**42-44 BOOREA  
STREET,  
LIDCOMBE  
SSD-36464788**

Submissions Report

**HALE PROPERTY SERVICES PTY LTD**

8 December 2022

Figure 1 – Ground Floor Plan

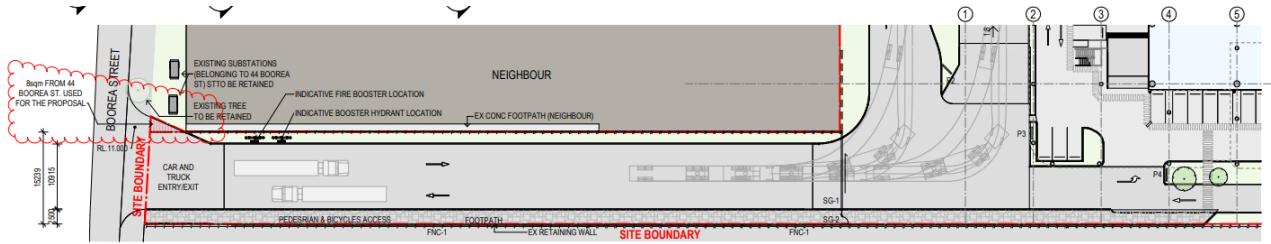
Clause 37 of *Environmental Planning and Assessment Regulations 2021* requires an amended application to provide details of the change, including the name, number and date of any plans that have changed, to enable the consent authority to compare the development with the development originally proposed. Three plans have been updated to incorporate part of the lot including:

An extract of the Ground Floor Plan, Figure 1 clearly shows the lot boundaries overlaid with site boundary extent required. The additional 8m<sup>2</sup> area is clearly identified on the plan with a 'bubble' around the amended

- Site Analysis Plan and Summary DA050 Revision H dated 2.12.2022
- Ground Floor Plan DA100 Revision N, dated 2.12.2022
- Services/Constrains Plan DA 106 H, dated 2.12.2022
